SUNDRY NOTICES AND REPORTS ON WELLS

PLUG AND ABANDONMENT PROCEDURE

Candado #7

CONDITIONS OF APPROVAL

Proposed P&A

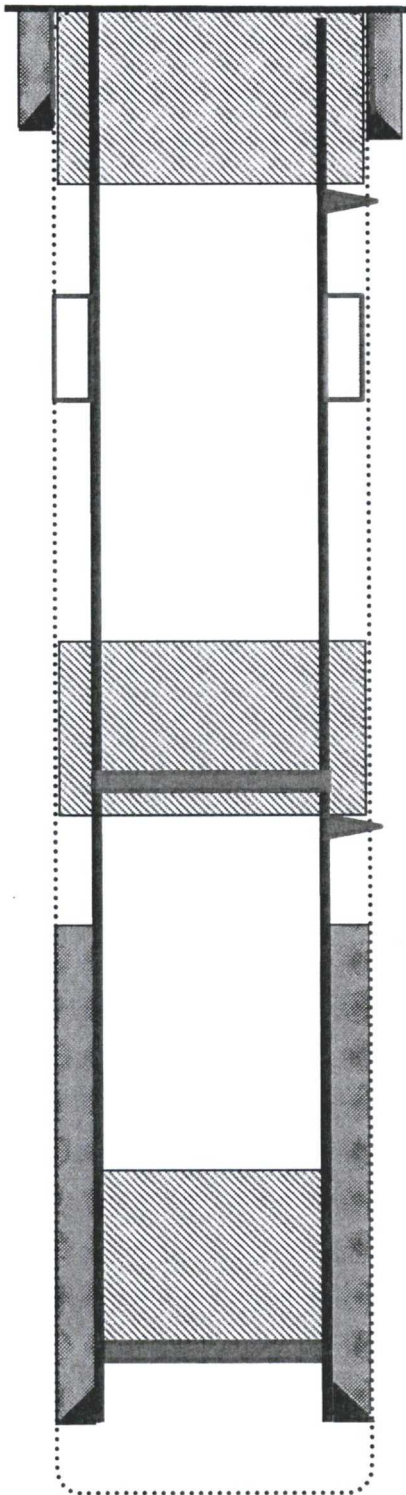
- a) Set Plug #1 (2187 - 1935) ft. to cover the PC and Fruitland tops. BLM picks top of Fruitland at 1985 ft.
- b) Set Plug #2 (1666 - 1367) ft. inside/outside to cover the Kirtland and Ojo Alamo tops. BLM picks top of Kirtland at 1616 ft. BLM picks top of Ojo Alamo at 1417 ft.
- c) Set Plug #3 (360 - surface) ft. inside/outside to cover the Nacimiento top. BLM picks top of Nacimiento at 310 ft.
